**APPLICATION FOR PERMISSION
UNDER SECTION 16 OF
THE TOWN PLANNING ORDINANCE
(CAP. 131)**

**Planning Application
under Section 16 of the
Town Planning Ordinance (Cap.131)**

PLANNING STATEMENT

Section 16 Application for Proposed Redevelopment of Anton Villa at 313 Castle Peak Road, Ting Kau, N.T.

SITE PLAN
1:300

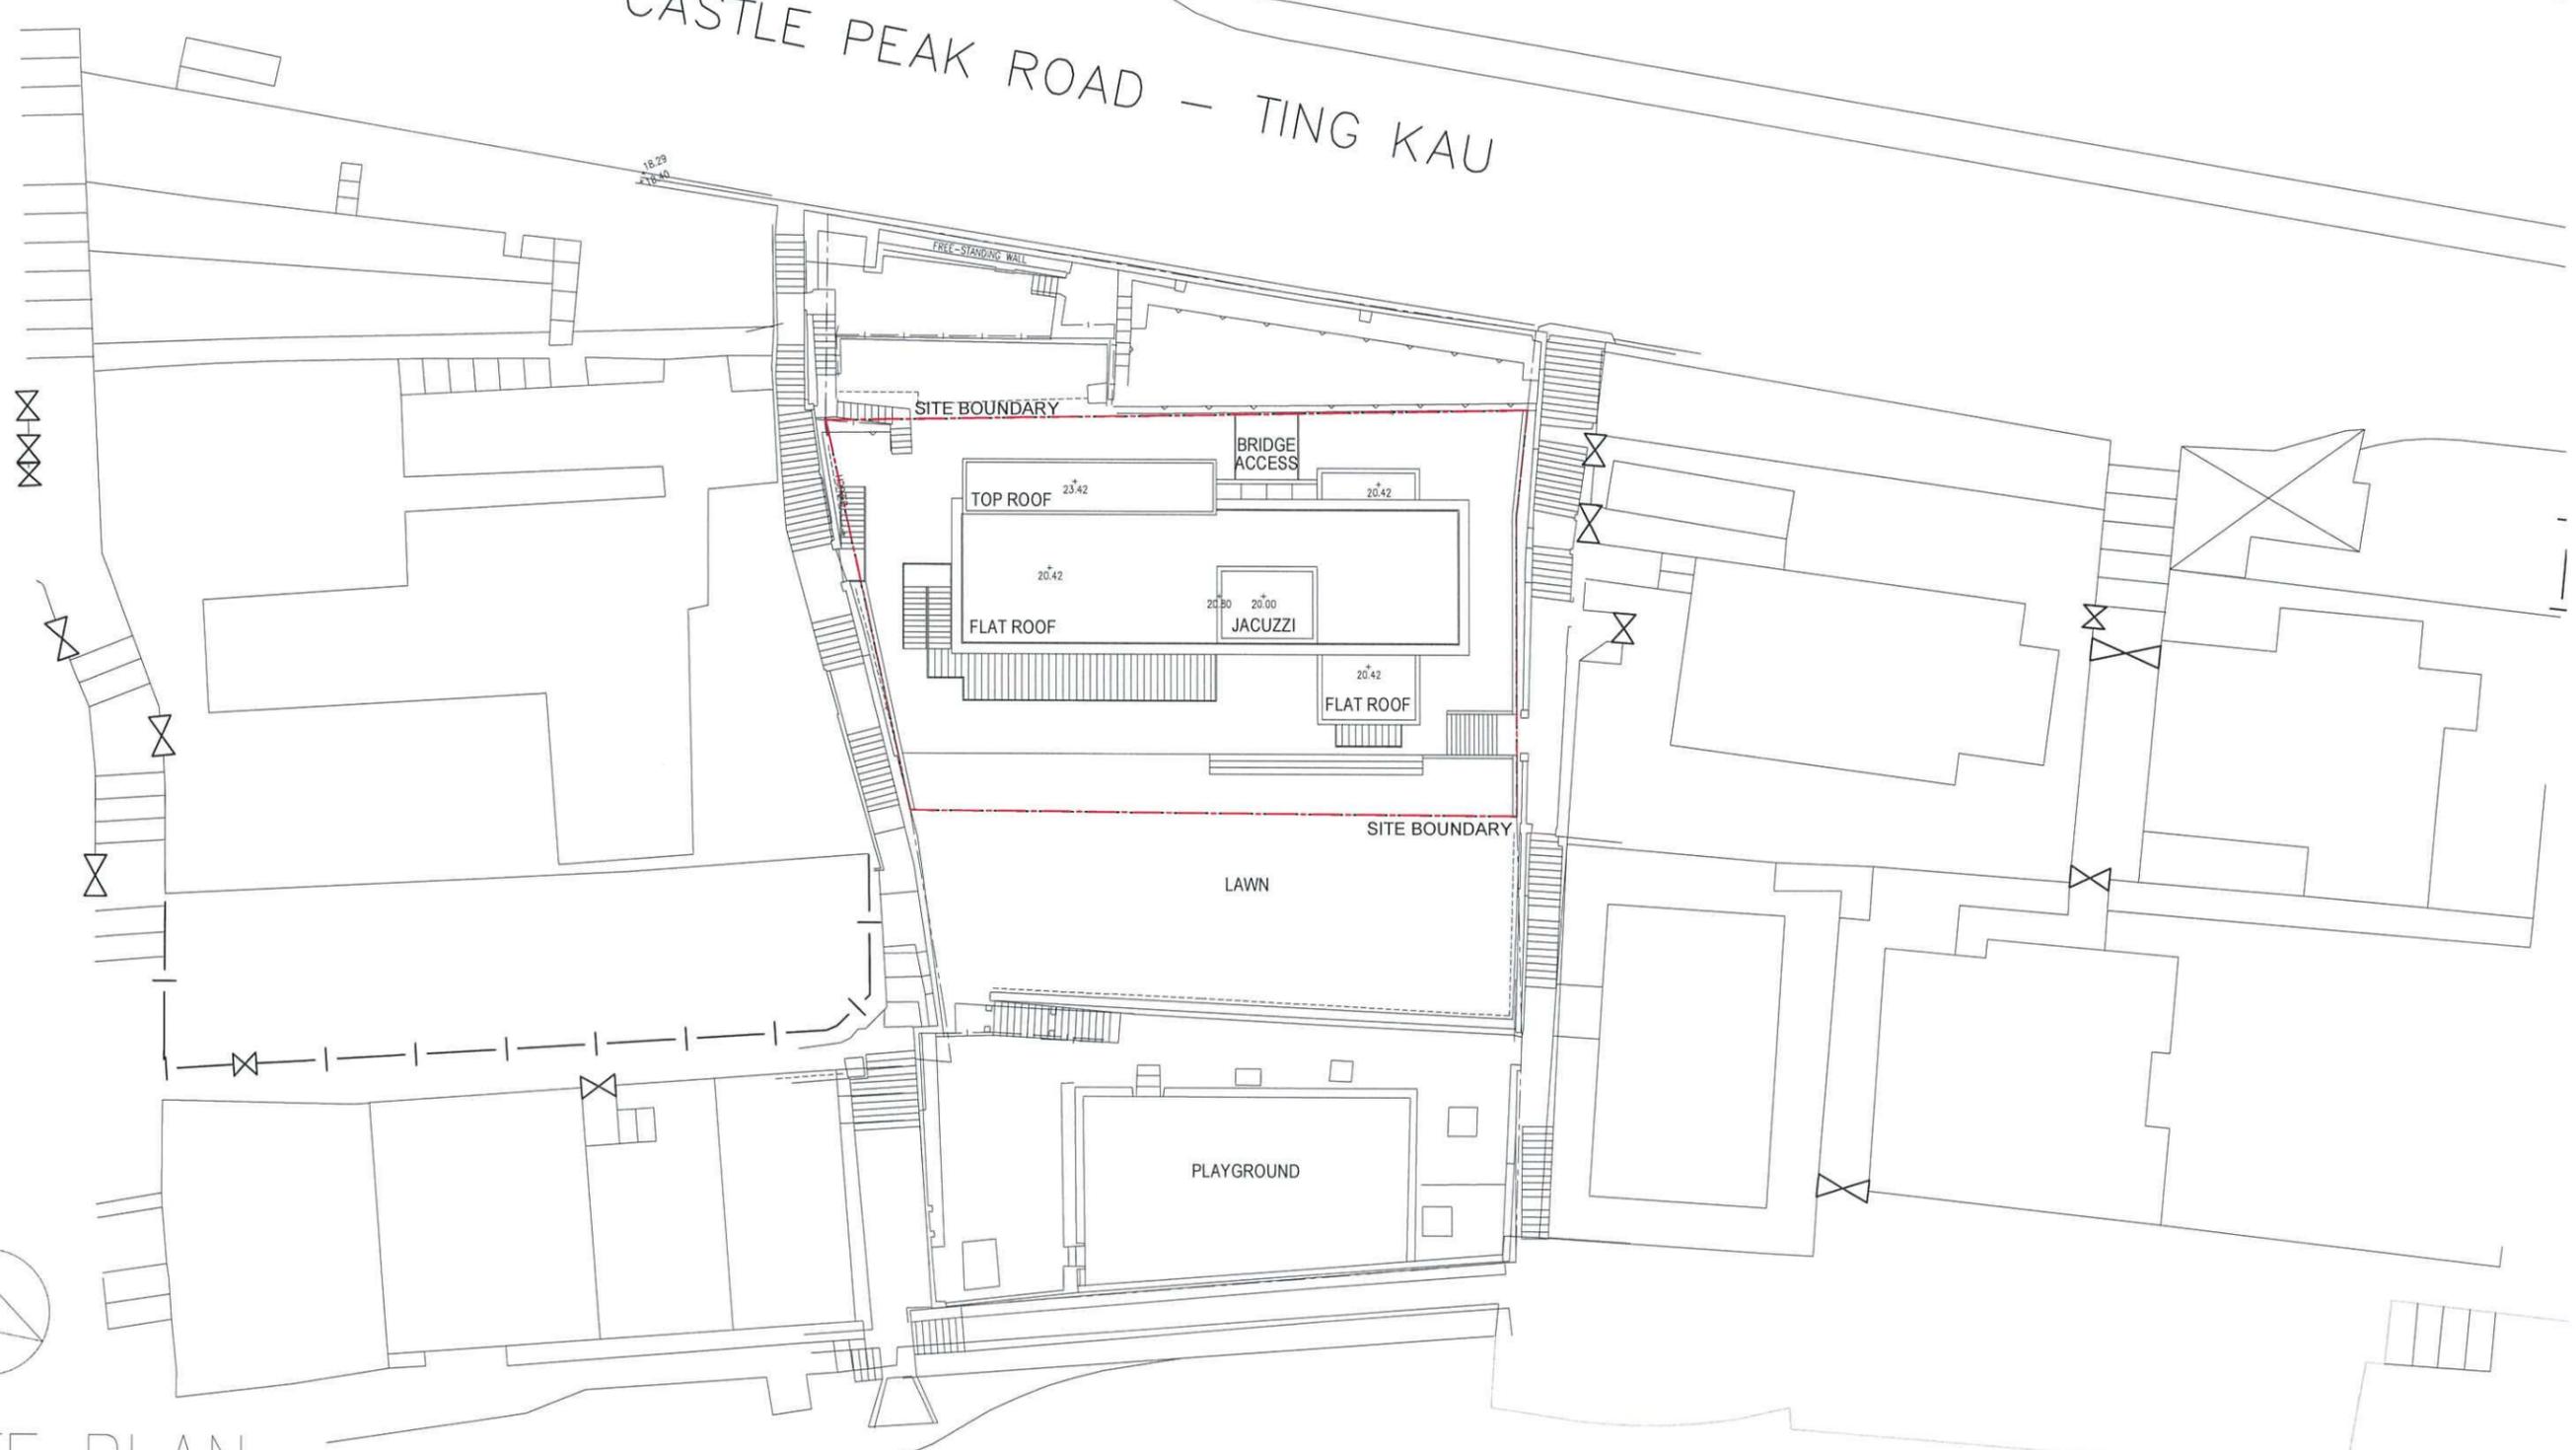
Comments	Response
1.	Comments from Tsuen Wan and West Kowloon District Planning Office, PlanD (Contact Person: Ms. Jacqueline CHAN // Tel: 2417 6686)	
L.	Please clarify whether the building height is “about 20.42mPD (measured up to main roof level)” or “not more than 20.42mPD (measured up to main roof level)”.	We wish to clarify that the building height is "about 20.42mPD (measured up to main roof level".
2.	Drawings 1 and 2 of Appendix 4 (Proposed Floor Layout Plans) — Please explain the meaning of the colours used in Drawing 1 by adding legends as necessary.	Please refer to supplementary attachment.
